WATER LICENCE INSPECTION FORM

Licensee			Licensee Represei	itative	
Hamlet of Cape Dorset Bhabesh Roy					
Licence No. / Expiry			Representative's	litle	
3BM-CAP1925	3BM-CAP1925 Municipal E			ngineer	
Land / Other Authorization	ons		Land / Other Auth	orizations	
Date of Inspection			Inspector		
02/07/2020			Joseph Mon	teith	
Activities Inspected	D. Dailling	□ Minima	П Салании.at	an Dealementian	□ Swal Starrage
Camp Roads/Hauling	☐ Drilling ☐ Other: Potable Wate Treatment, and Solid Wa	☐ Mining r Source, Waste Water astes	☐ Constructi ☐ Other:	on Reclamation	☐ Fuel Storage
Conditions:	A- Acceptable	U-Unacceptable	C-Concern	NI-Not Inspected	NA- Not applicable
PART:				Condition	Observation No.*
A: SCOPE, DEFINITIO	NS AND ENFORCEME	NT		NA	
B: GENERAL CONDIT	IONS			С	1-3
C: CONDITIONS APPL	YING TO SECURITY			NI	
D: CONDITIONS APP	LYING TO WATER USE	<u> </u>		А	4-10
E: CONDITIONS APP	LYING TO WASTE DISF	OSAL AND MANAGE	MENT	С	11-21
F: CONDITIONS APPL	YING TO MODIFICATI	ONS		NI

On July 2, 2020, a water licence inspection was conducted at the Hamlet of Cape Dorset, Qikiqtani Region, Nunavut, to verify terms and conditions of the water licence, and the Nunavut Waters, and Nunavut Surface

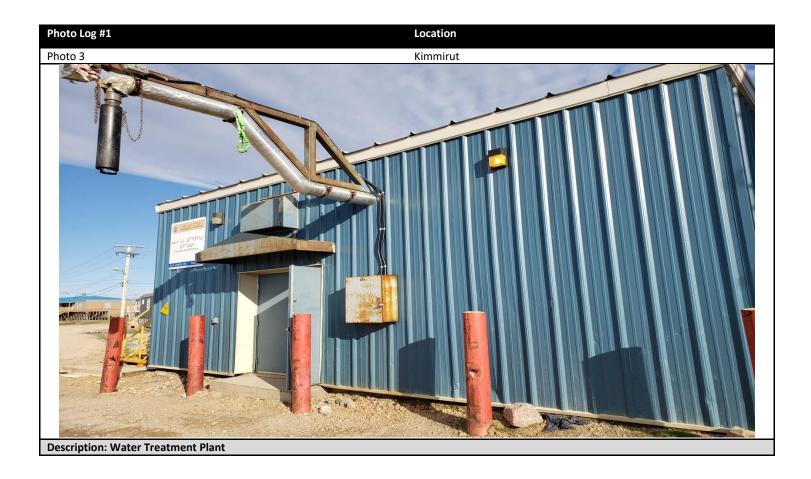
- 4. Water is being withdrawn from Tee Lake as approved in the expired Water Licence at Latitude: 64° 12.916'N, Longitude: 76° 32.448'W (photo 1).
- 5. At the time of the inspection no water use records were provided.
- 6. On October 25, 2018 William Koonoo, Municipal Technical Clerk for the GN-CGS provided the Delivery Summary

- by Month and Year showing that 35,212m3 matching the 2018 Water Consumption Report.
- 7. During the inspection WRO Monteith did observe rusting of the pipe at Tee Lake below grade of the water table. (Photo 1).
- 8. Monitoring Station Cap-1 was observed at the water fill station.
- 9. The length of piping from the potable water source to the truck fill station is approximately 1,318.93 metres (1.3km) as measured from GoogleEarth (photo 2).
- 10. The Hamlet water fill station was observed. No water metre was observed at the time of the inspection.

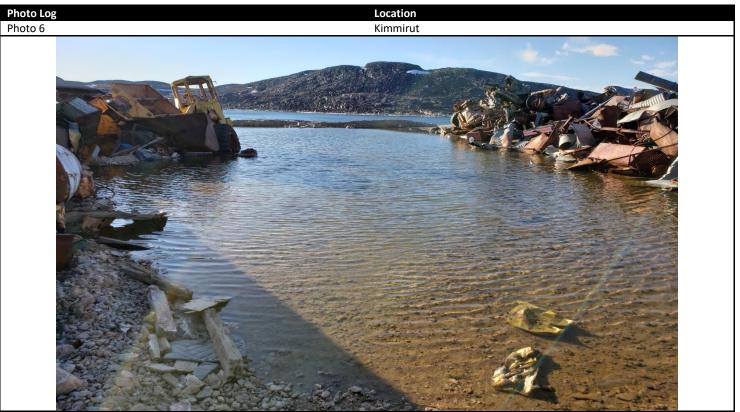
Description: The uncontrolled discharge of sewage down the spill way has caused erosion and sedimentation. A spill report was requested and submitted to the NT\NU Spills line.

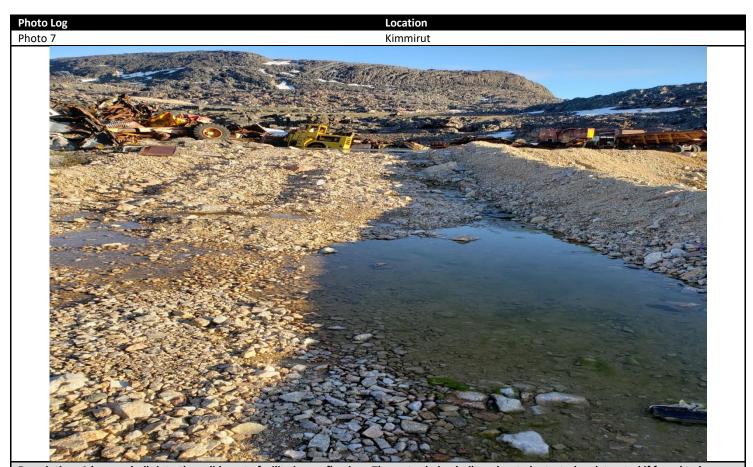
Description: A berm rebuilt into the solid waste facility is full, and over flowing. The water being built up has to be tested, and if found to have contaminants treated before being released.

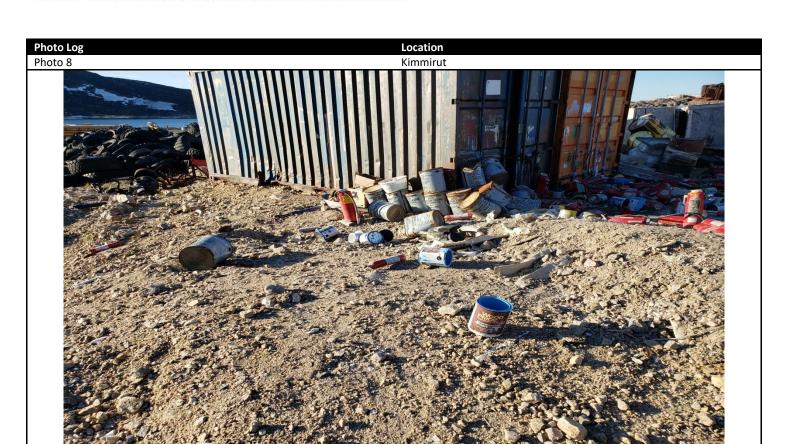
Description: A berm rebuilt into the solid waste facility is overflowing. The water being built up has to be tested and treated if found to have contaminants before being released.

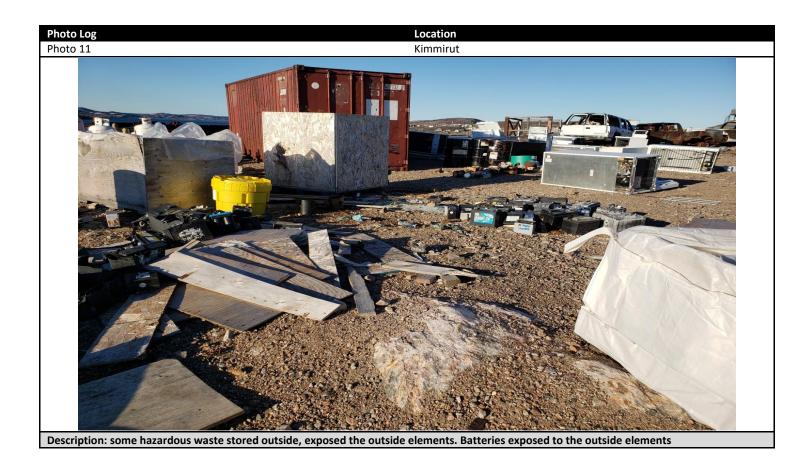
Description: stored paint cans outside to the outside elements gets kicked around and litter the grounds of the solid waste facility

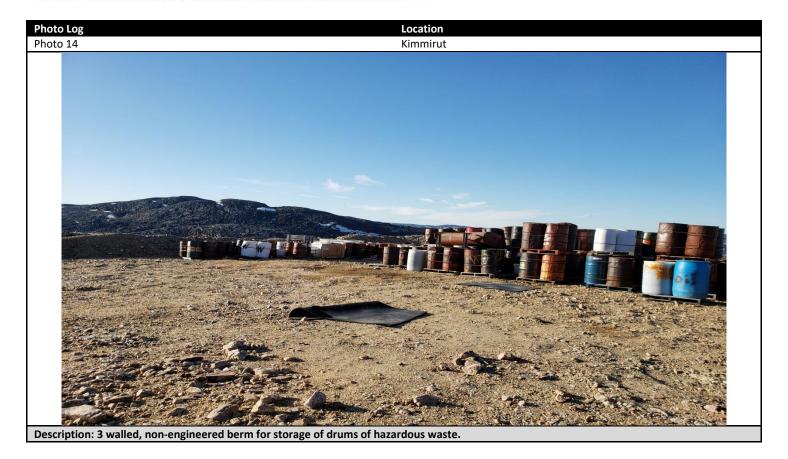
Description: Unreported spill at the emergency lagoon. A spill report submission was requested, and clean up. Walls of emergency sewage lagoon repaired, and 1 metre free board now maintained.
